## PIC16C74B Rev. A Silicon Errata Sheet

The PIC16C74B (Rev. A) parts you have received conform functionally to the Device Data Sheet (DS30605A), except for the anomalies described below.

**FIGURE 1:  $\overline{\text{MCLR}}$  EXTERNAL CIRCUIT**

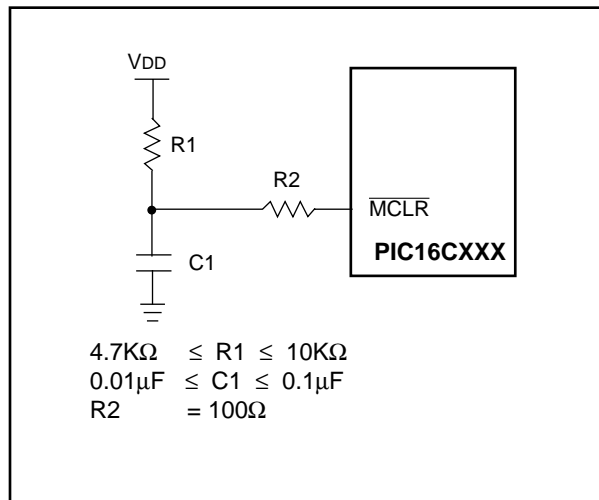
The minimum specification for the  $\overline{\text{MCLR}}$  must be met in order to RESET the PIC16CXXX. If a  $\overline{\text{MCLR}}$  pulse occurs that is less than the minimum specification (parameter #30), improper device operation can occur.

If the Minimum specification cannot be met, then an external circuit must be used to insure that any pulse width less than the specification will be filtered before it reaches the  $\overline{\text{MCLR}}$  pin.

A possible circuit is shown in Figure 1. Proper design validation needs to be done to ensure desired operation over the applications operating conditions

**Figure 1: Wake-up from Sleep**

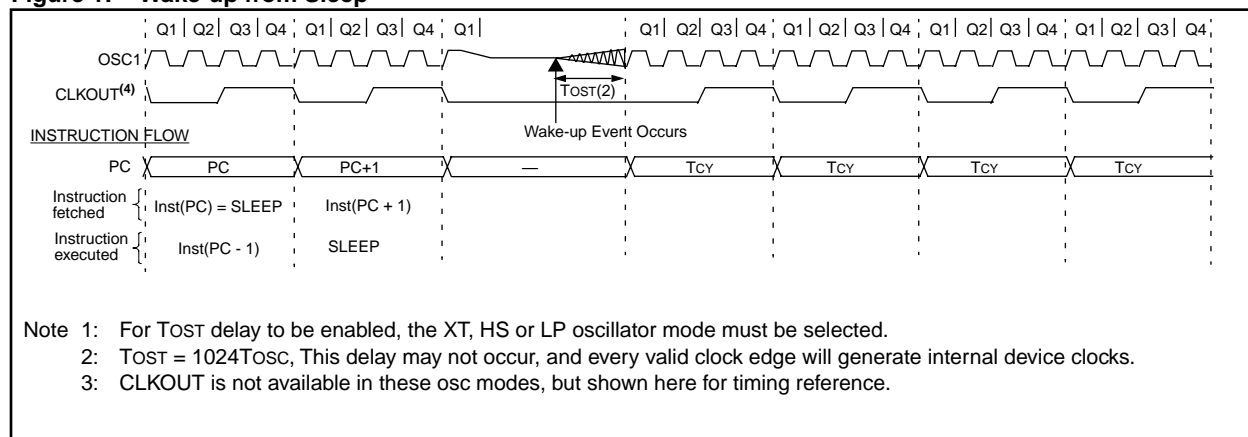
The Oscillator Start-up Timer (TOST) delay may not occur when the device wakes-up from sleep.

Figure 1 shows the start-up of the crystal after the event that causes the device to wake up from sleep mode (as specified in device data sheet). The start-up time (TOST) may not occur.

In applications where time based measurements are started immediately after wake-up from sleep, the suggested work around should be implemented.

After the SLEEP instruction, do a software delay of 256 Tcy (same as 1024 TOSC). At the Reset and Interrupt vector addresses, test to see if the device woke from sleep (the  $\overline{\text{TO}}$  and  $\overline{\text{PD}}$  bits), and if the device did wake from sleep, ensure that the total cycle delay is 256 Tcy.
